**Rehabilitation of the sewers,
the watermain and the
parking lot of the workshop
and rehabilitation of the 15,5
site of the Lachine Canal**

Addendum no 5

Project Number: CLAC-1803

May 8, 2019

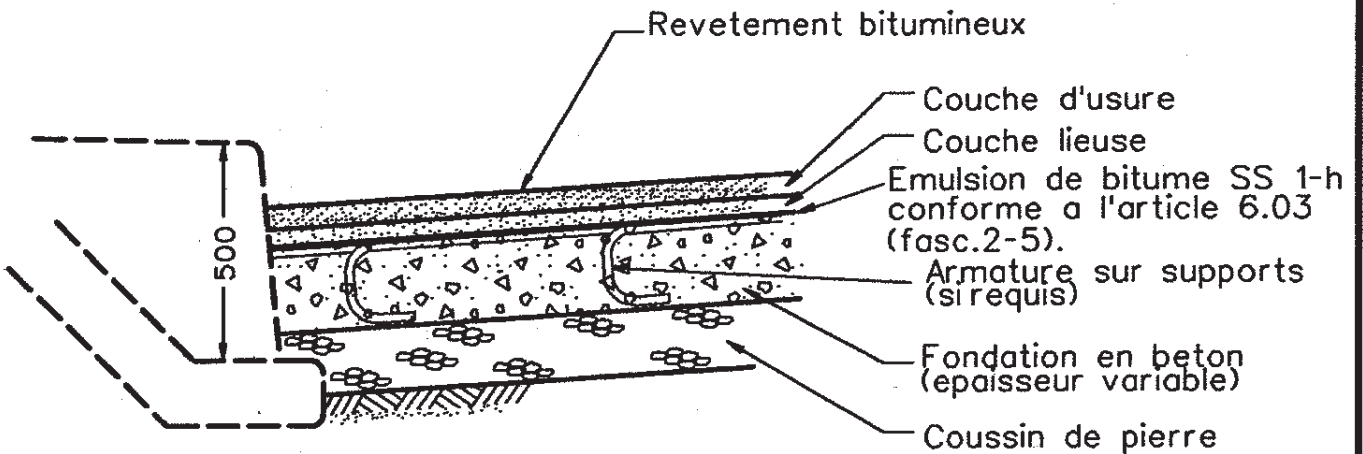
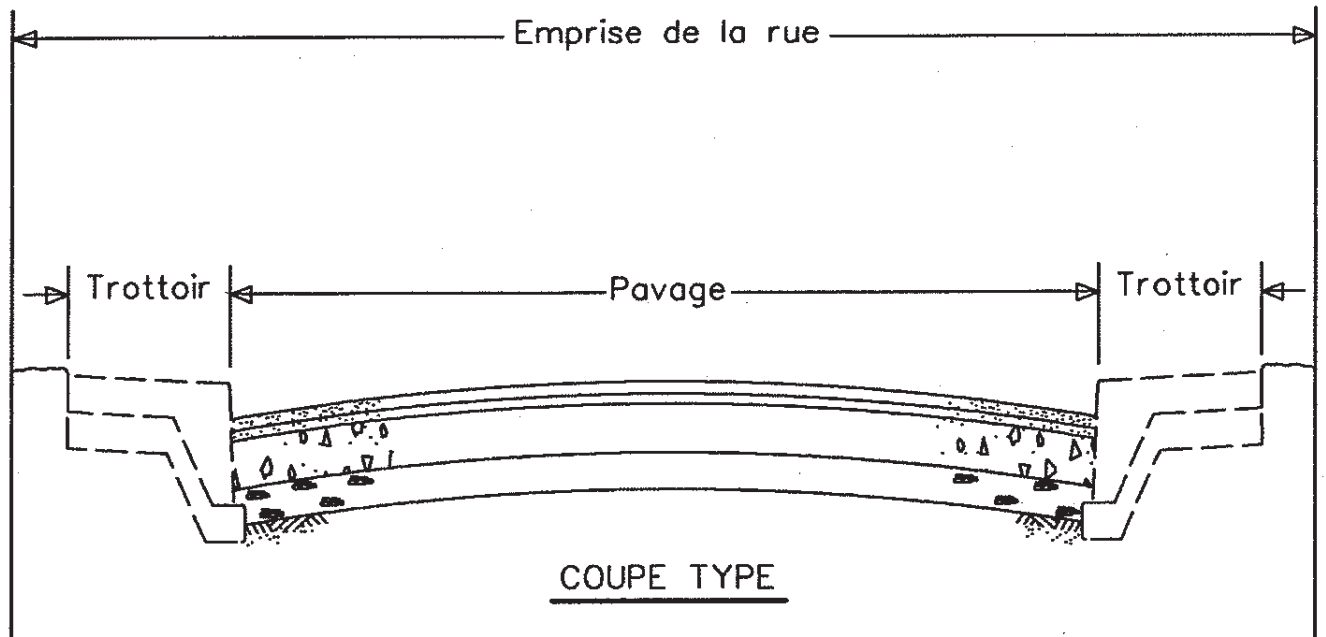
Item	Description	Quantity	Unit	Unit Price	Amount
1.7.8	Supply and installation of a retention basin, pipes 1200 mm diameter, including the drawings signed and sealed by an Engineer HDPE Plastic materials pipes (HDPE, polypropylene, FRP, ...) with a minimum stiffness of 320 kPa with smooth inside and outside walls with a minimum stiffness of 250 kPa according to the ASTM F894 standard, including the access chimneys	1	global	_____ \$	_____ \$
